**ADDENDUM NO. 6
NEW CREAMERY ROAD SEWAGE PUMP STATION
CONTRACT NO. 001**

Addendum 6, March 10, 2023.

Particle Size Distribution Report

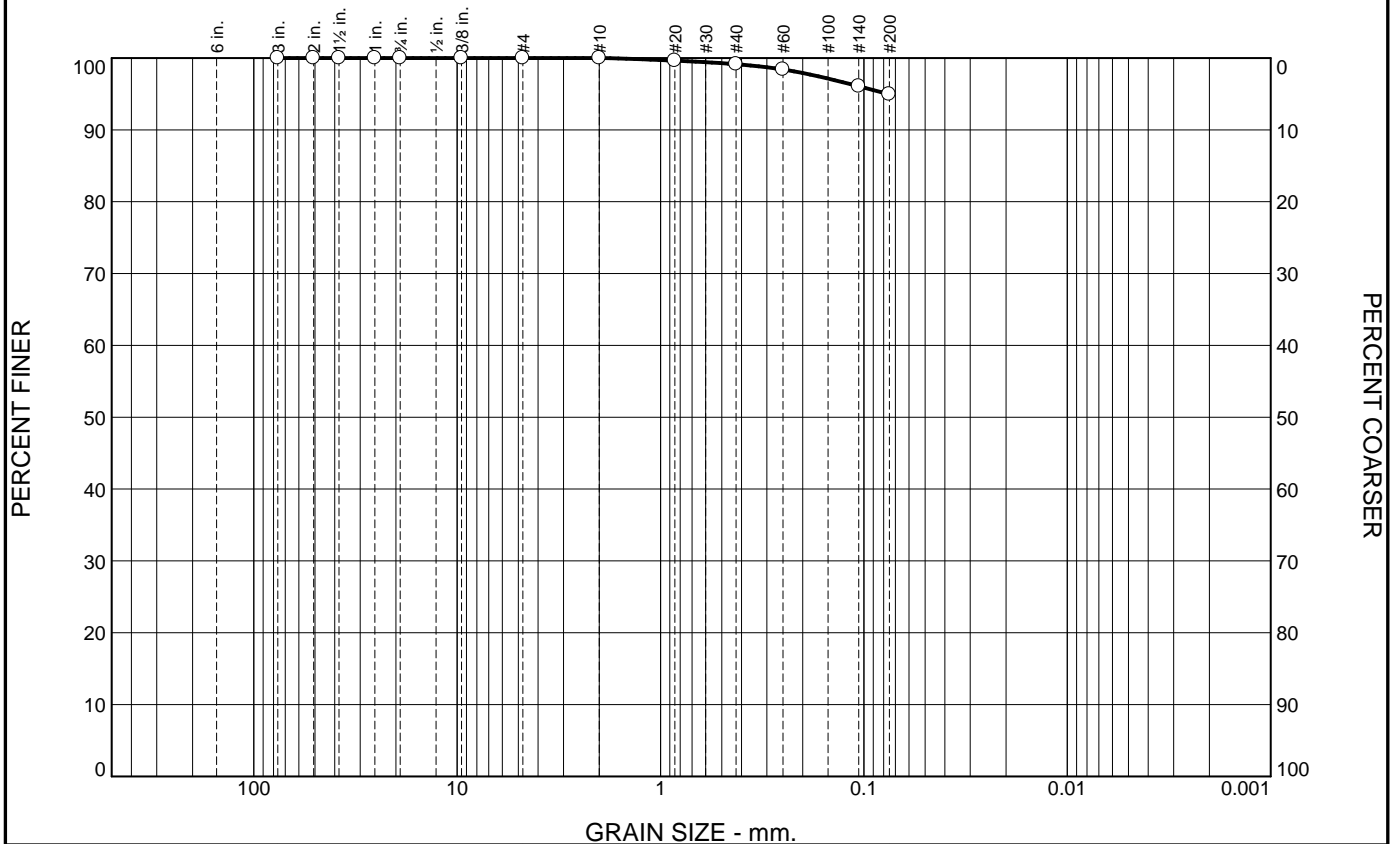
1. *Plan Sheet C2 shows the locations of Test Bores 505, 508, I1, I2, SWM 1. However, in the project manual we can only find Boring Logs for Borings B1 & B2. Please clarify the location on site of Borings B1 & B2, and also provide bore logs and soils information for all test pits/borings shown on plan sheet C2.*

All test bores labeled 505 and 508 shall refer to Borings B-1 and B-2, respectively. Revised Sheet C2 and SWM-1 are included in Addendum 5. Bore logs/soils information for SWM-1 are attached. Infiltration rates for Borings I-1 and I-2 are also attached.
